**TSB-285**

**Land Rover Defender Concentric Slave Cylinder Supersession**

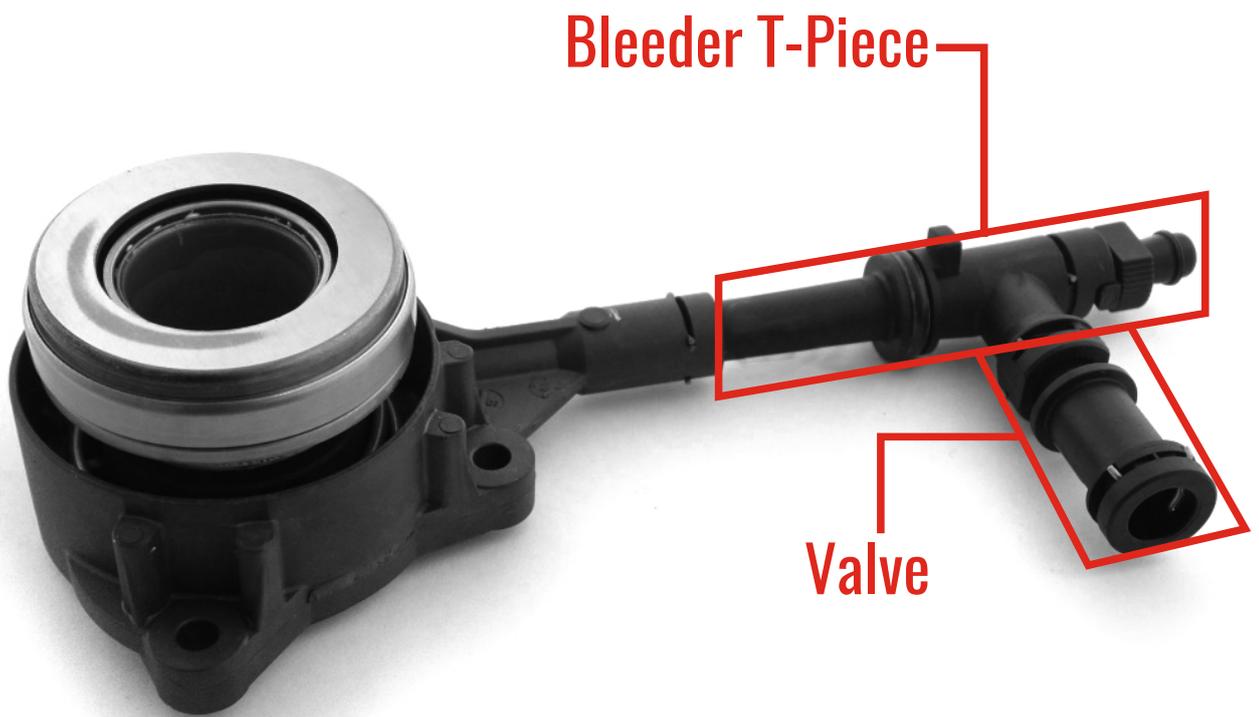
The Concentric Slave Cylinder (CSC) in this vehicle has undergone supersession from Land Rover at an OE level. This means that the vehicle may have 1 of 2 CSC's fitted that aren't directly interchangeable without supporting componentry.

ACS offers one type of CSC and an adapter assembly that consists of a valve and bleeder T-piece. This combination will fit both vehicles.

**Note:** You may not need to use the adapter pieces. If they are required, the bleeder T-piece is installed into the slave cylinder and the valve is installed into the bleeder T-piece.
